H5 Network PTZ Dome Camera Firmware

Version: V5.5.27 Release Note

(2020-03-11)

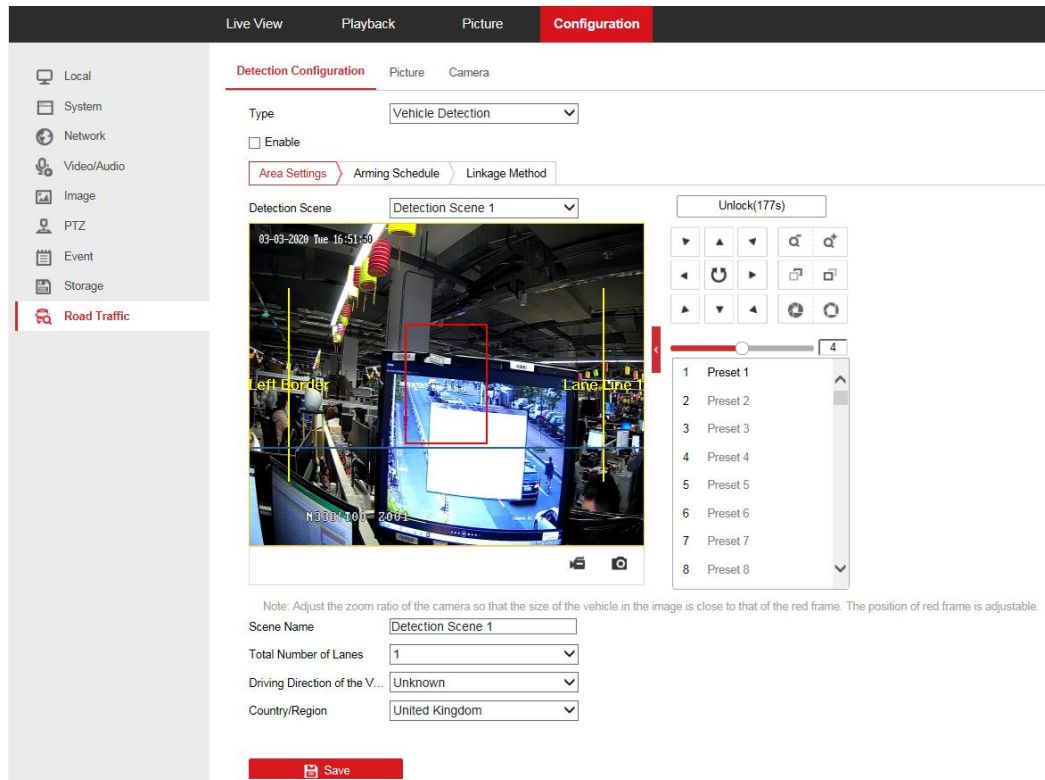
- **Newly support Road Traffic function. Support 100 countries in web browser and display United Kingdom by default:**

1. Only the Vehicle Detection type is supported. The vehicle detection does not distinguish between the Entrance/Exit mode and City Street mode, and takes effect directly according to the City Street mode.

2. Does not support motorcycle identification.

3. Does not support vehicle feature recognition.

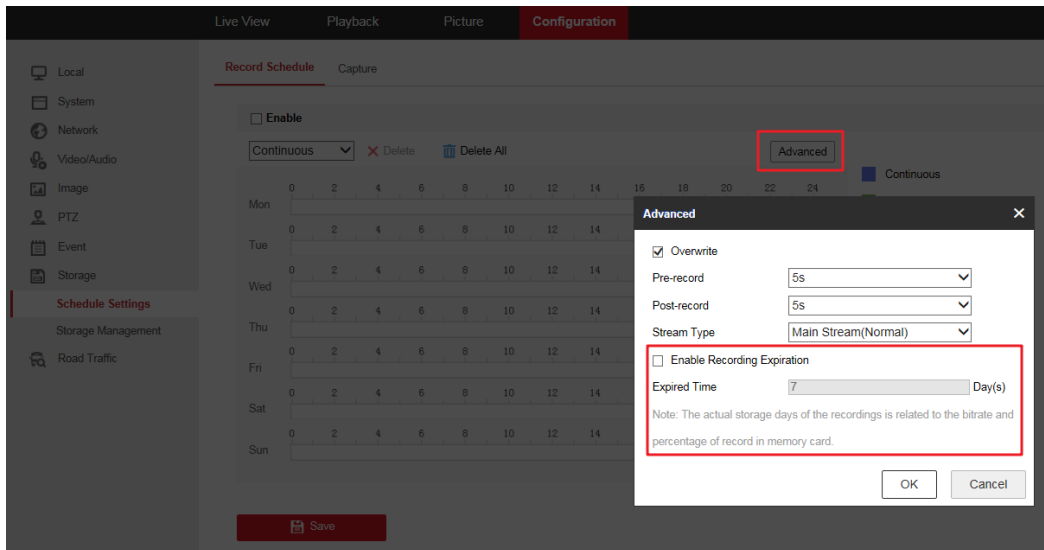
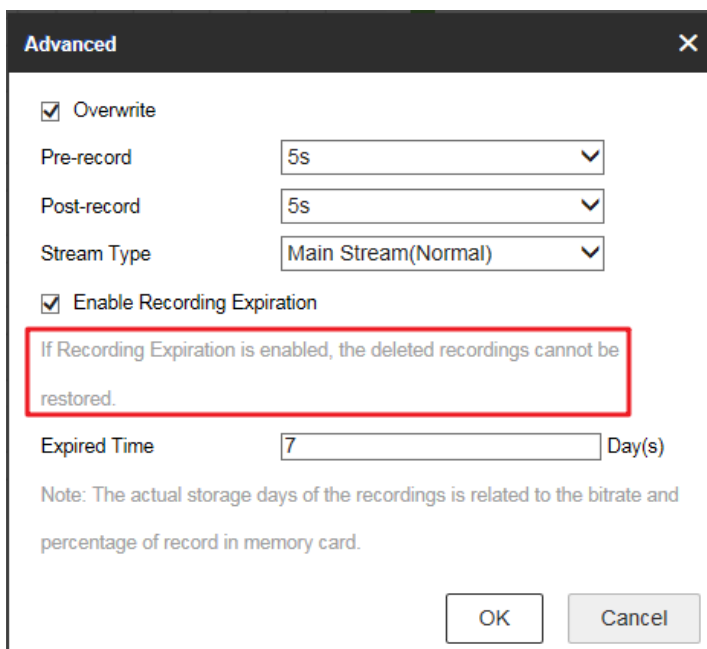
- **Newly support Recording Expiration in Recording Schedule. Records that exceed the Expired Time need to be deleted, and deleted videos cannot be recovered.**

1. The Recording Expiration is disabled by default.

2. The expired time is in days, ranges from the 1 to 90 and the default is 7 days.

3. After enable this function, a prompt message will pop up: If Recording Expiration is enabled, the deleted recordings cannot be restored.
